# CITY PLANNING COMMISSION

- APPLICATION:
1. Negative Declaration
  2. Rezone 7.5± acres from Single Family (R-1) to Townhouse (R-1A) zone (Sec. 13)
  3. Tentative Map to divide 37 corner lots into 74 halfplex lots (Sub. Ord.)
  4. Special Permit to create 74 halfplexes (Sec. 7 & 15)
  5. Subdivision Modification to waive separate water and sewer services

LOCATION: Various corner lots in Lakecrest Village Unit No. 4

APPLC. NO. P84-182

UNIT 2392 FLOOR PLAN

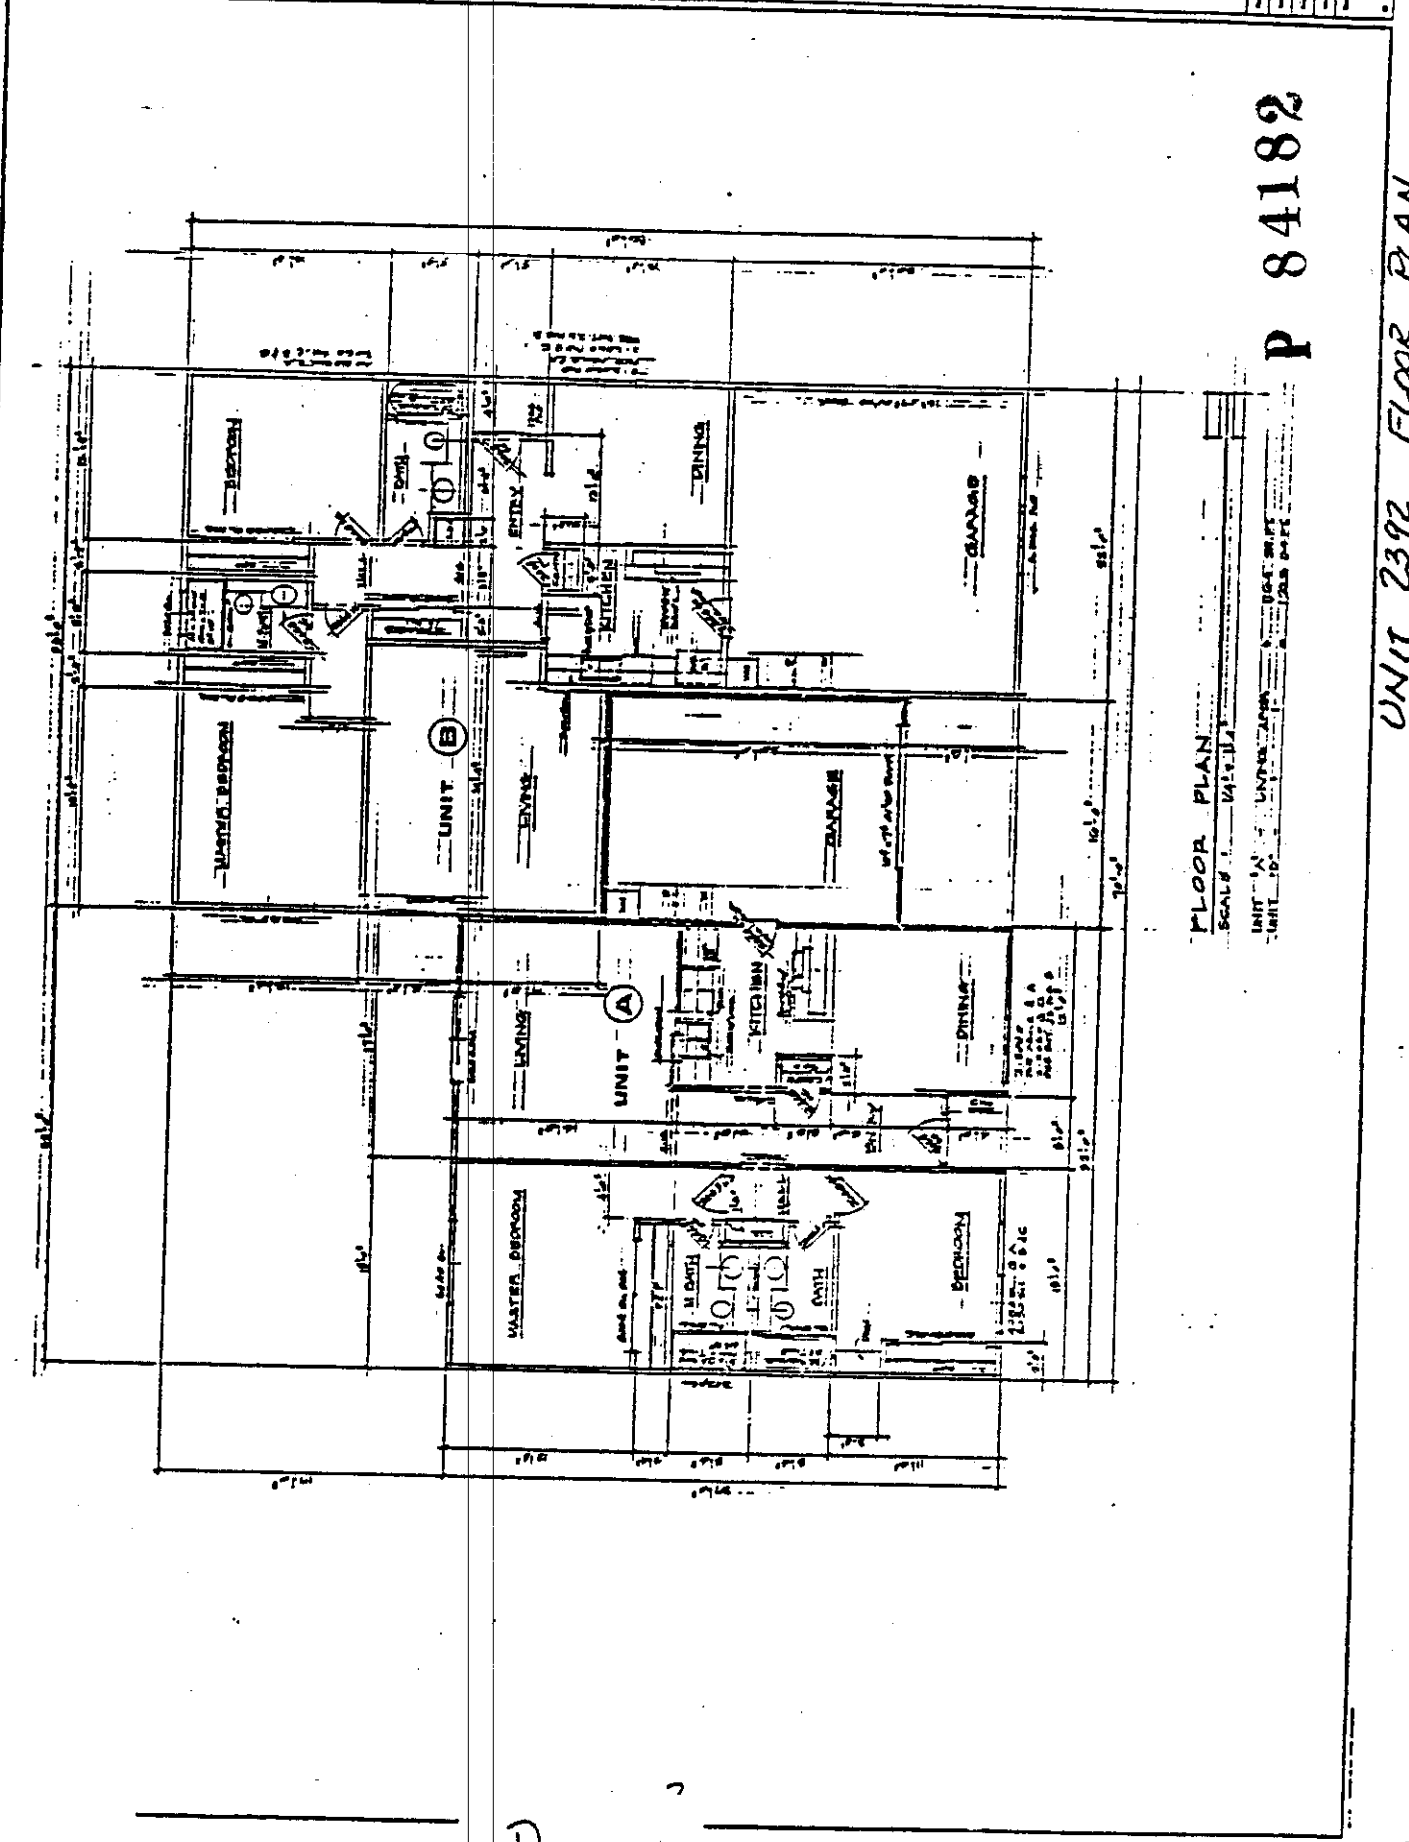
Informational Items: 1) Redesign all 2392B units so that driveway is located outside of the radius of the corner to the satisfaction of the City Traffic Engineer;  
2) Garage doors must be a minimum of 20 feet behind property line.

4. The applicant's proposal was reviewed by the City Traffic Engineer who indicated that some of the units will require redesign so that the driveway will not be located in the corner radius. In addition to this concern, the Traffic Engineer also requires that each driveway be a minimum of 20 feet long. These comments were noted as informational items during the Subdivision Review Committee hearing.

- a. The applicant shall redesign all units where the driveway is located in the corner radius to the satisfaction of the Traffic Engineer prior to issuance of a building permit. All driveways shall be a minimum of 20 feet in depth;
- b. The applicant shall adhere to the attached site plans. Varied exterior materials shall be utilized on adjacent halfplex structures. Plans shall be submitted to the Planning Director prior to issuance of a building permit.
